OLMSTED LOCKS AND DAM: ILLINOIS AND KENTUCKY POST AUTHORIZATION CHANGE REPORT

A PROJECT MODIFICATION RECOMMENDATION FOR THE OLMSTED LOCKS AND DAM

SUBJECT: Locks and Dams 52 and 53 Replacement Project (Olmsted Locks and Dam, Illinois and Kentucky), Post Authorization Change Report (PACR) dated November 2011

POST AUTHORIZATION CHANGE REPORT

FIGURE 1

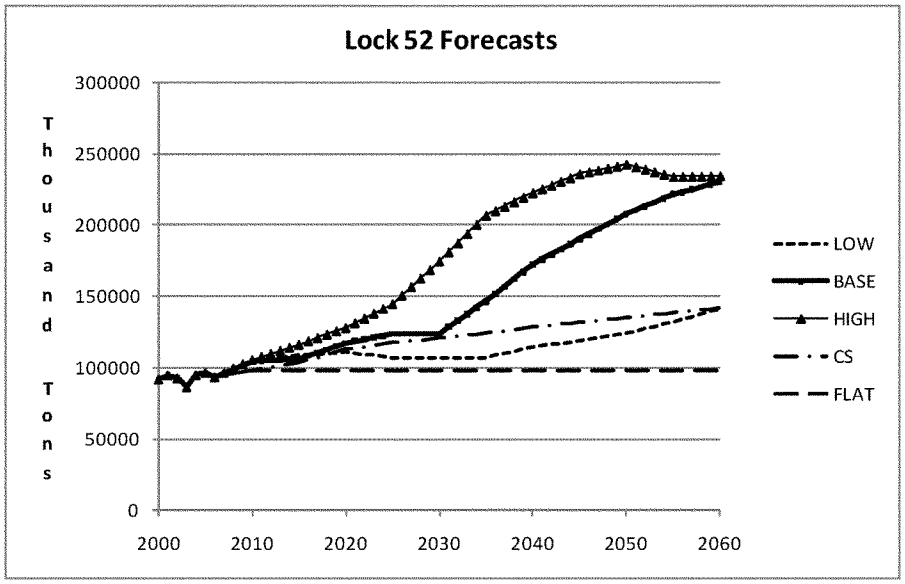
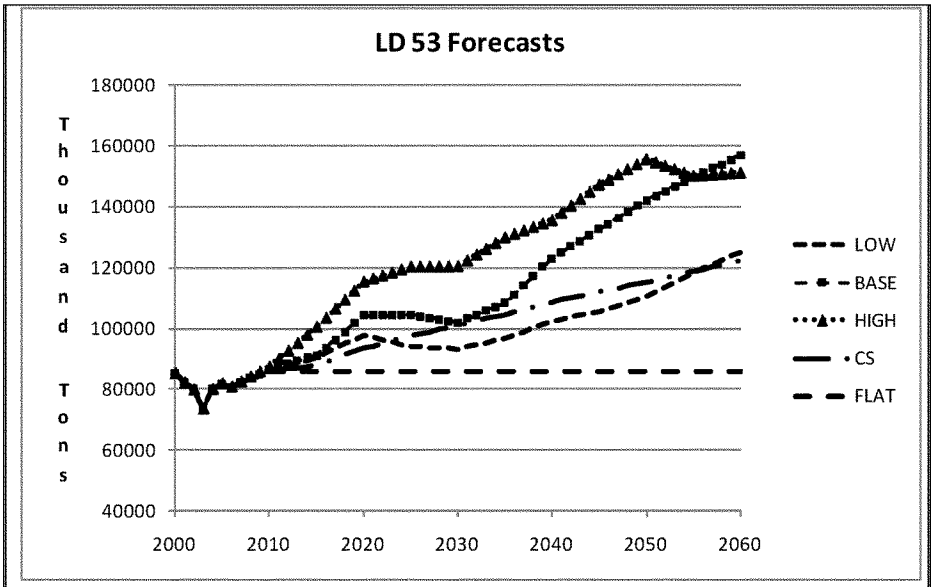
Figures 1 and 2 show the traffic forecasts for Locks 52 and 53. The Clear Skies scenario is shown along with the Low Case, Base Case and High Case scenarios from the updated ORS traffic forecasts. Also shown is a flat forecast that was used for a sensitivity test in the Olmsted PACR. Except for the early years, the updated Low Case scenario is actually somewhat lower than the Clear Skies scenario over most of the forecast horizon at both projects. This is attributable, in large part, to the effects of strict, national-level restrictions on CO2 emissions contained in the Low Case scenario. However, the flat forecast, which is actually Clear Skies flattened after 2010, is lower than both Clear Skies and the Low Case scenario. The sensitivity test using the flat forecast indicates that the Olmsted project remains justified. This would appear to indicate that additional sensitivity tests are unnecessary.
